Kirby Morgan Dive Systems, Inc.®

Bulletin #6 of 2015. May 4, 2015

Maintenance & Repair Bulletin

No Loctite®

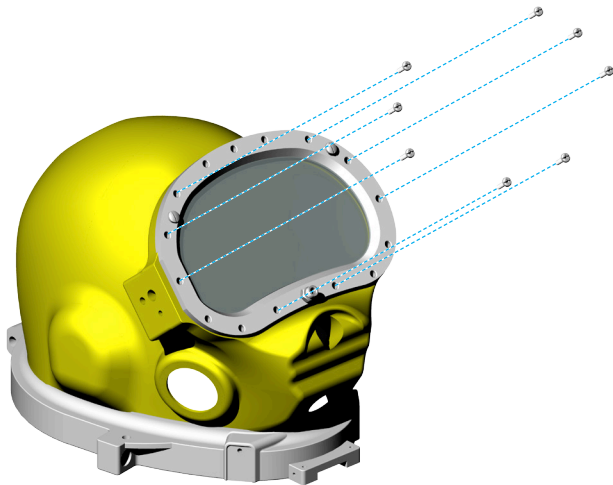
When reinstalling the port retainer screws on fiberglass helmets, DO NOT use Loctite® thread locker.

With Loctite®

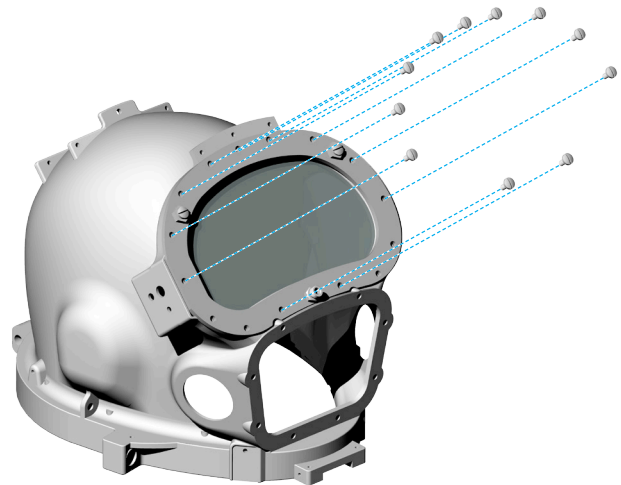
When reinstalling the port retainer screws on stainless steel helmets, Loctite® 248 Medium Strength, non-drip thread locker is used.
